HARBOR BROOK TREATMENT WETLANDS CSO STORAGE

CONTRACT NO. 1 - GENERAL

ONONDAGA COUNTY DEPARTMENT OF WATER ENVIRONMENT PROTECTION SYRACUSE, NEW YORK

RECORD DRAWINGS

SCALE: 1/2" = 1'-0"

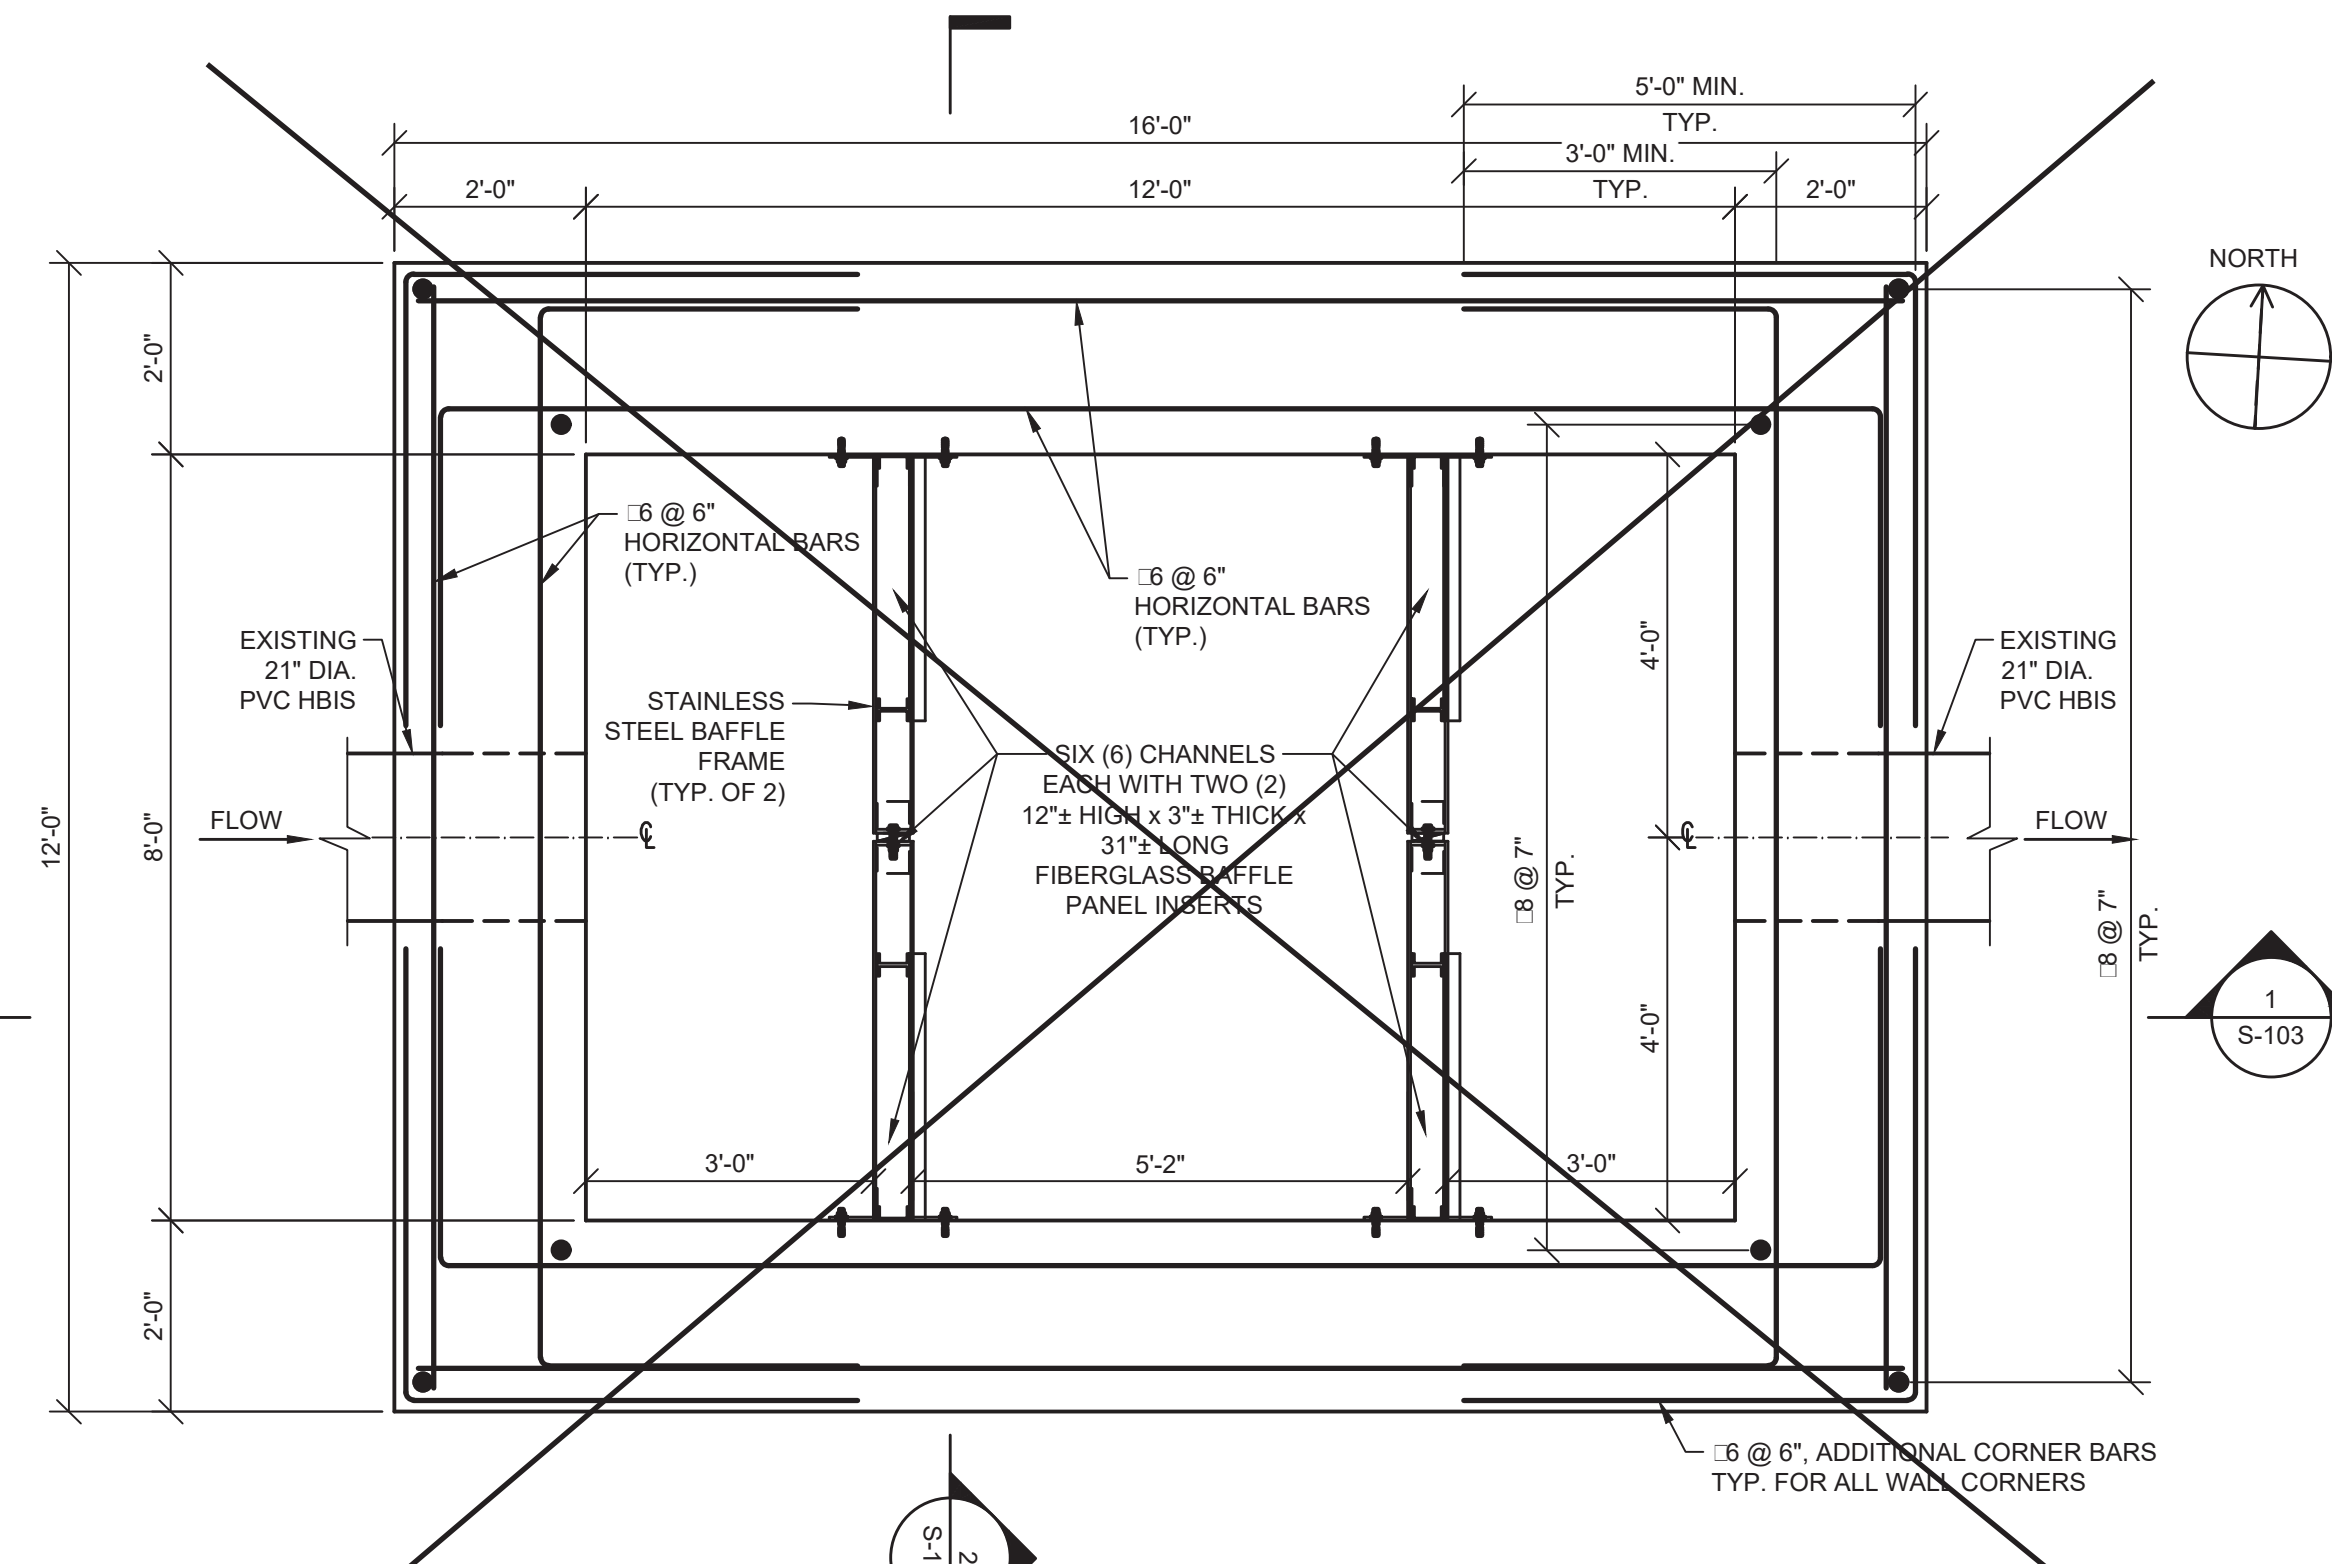
GRIT CHAMBER ELIMINATED BY MODIFICATION NO. 1, 6/10/2021
